Amendment to the Drawings:

REMARKS

"ANNOTATED SHEET SHOWING CHANGES"

Fig. 1

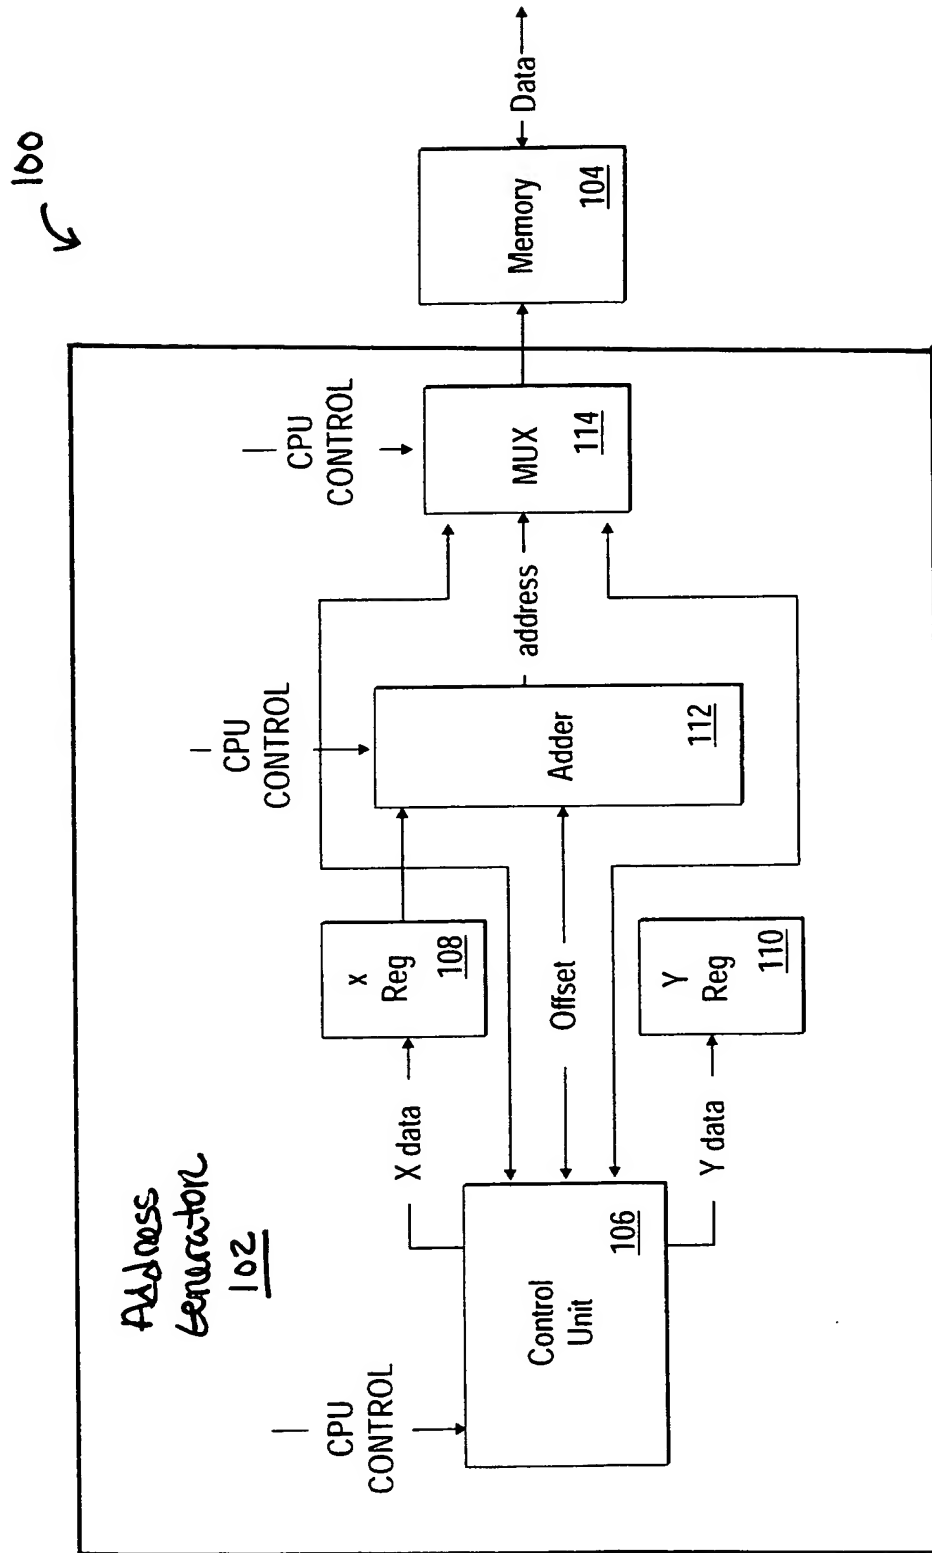
Applicant respectfully notes that figure 2 has been corrected to indicate "count_enable" for item 210 and "counting control logic" for item 204. Figure 3 has been corrected to indicate "Xstep" for item 314. Figure 1 has been amended to show "system 100" and "address generator 102."

Figure 1 has been amended to show "system 100" and "address generator 102."
